Subject: Duke Energy Corporation
Oconee Nuclear Station - Units 1, 2, and 3
Docket Nos. 50-269, 50-270, and 50-287

Revisions to Topical Reports DPC-NE-3000 and 3005 In
Support of Steam Generator Replacement
Response to NRC Staff Request for Additional
Information

**Duke Power Response To
Request for Additional Information Regarding Topical Reports
DPC-NE-3000 Revision 3
“Thermal-Hydraulic Transient Analysis Methodology”
and
DPC-NE-3005, Revision 2
“UFSAR Chapter 15 Transient and Accident Methodology”**

Figure 15-17
LARGE STEAM LINE BREAK
WITHOUT OFFSITE POWER

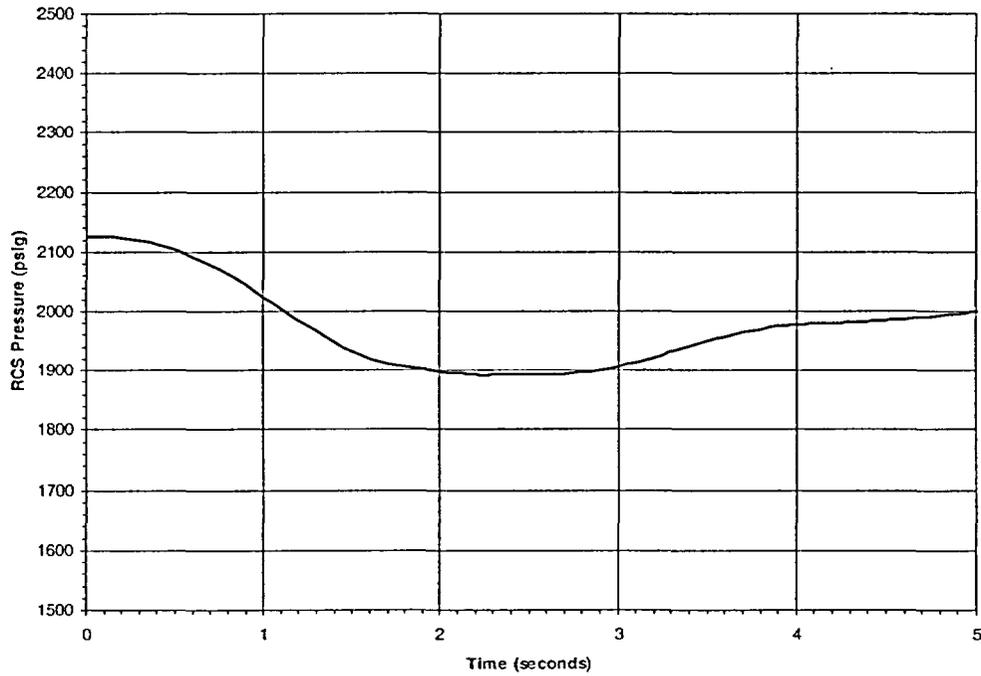
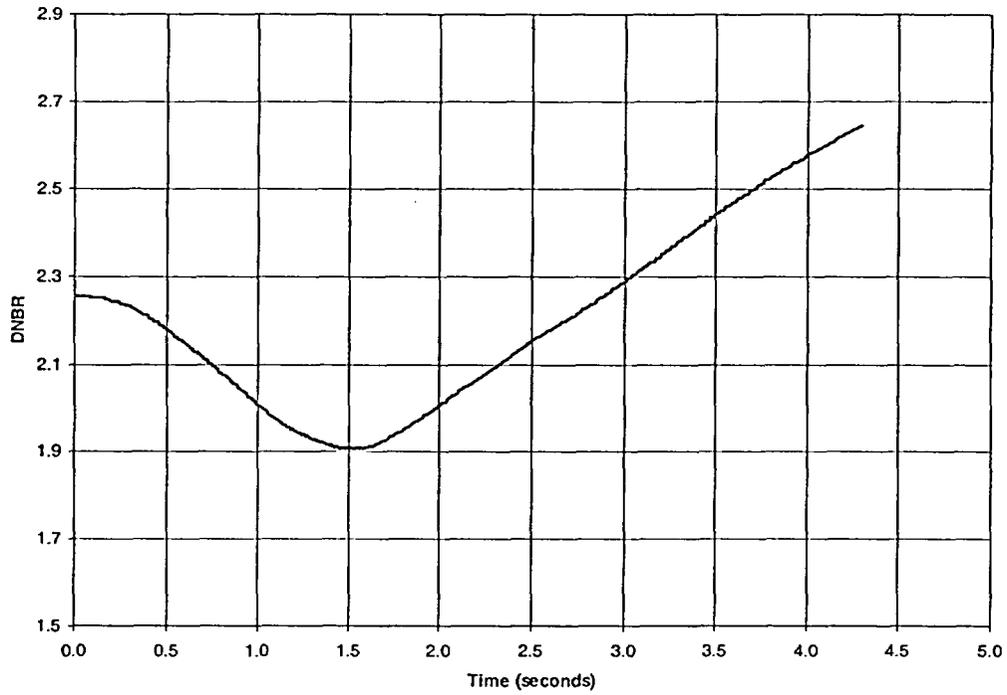
24. Page 5-36 to the revisions to DPC-NE-3005-PA states that the only significant difference between the transient thermal-hydraulic behavior with the new steam generators will be for the main steam line break analysis, in which the flow restriction orifices in the outlet nozzles will effectively reduce the minimum break size and blowdown rate. In addition the new steam generators will have a greater heat transfer area and a greater water mass. Differences in calculational models between RETRAN-02 and RETRAN-3D may also affect the result. In particular assumptions for phase separation within the steam generators and steam flow rate from the break may affect the result. Please provide main steam line break analyses similar to those in Chapter 15 of DPC-NE-3005-P for cases both with and without offsite power for the new steam generators with RETRAN-3D.

Response: The revised topical report text and figures (included after the response to Question 29) show the RETRAN-3D main steam line break analysis results for both with and without offsite power with the replacement steam generators. A brief summary of the result of the analyses is as follows. The steam outlet nozzle flow restrictors cause a slower RCS cooldown and depressurization rate, which provide more favorable results. For the with offsite power case the slower cooldown rate does not result in a loss of the subcritical margin according to the RETRAN-3D and SIMULATE simulations. Consequently, no detailed core thermal-hydraulic analysis was performed. For the without offsite power case, the RCS depressurization rate is slower, and the statepoint at the time of minimum DNBR is more favorable. Consequently an increase in DNBR margin is gained relative to the previous RETRAN-02 OTSG analyses.
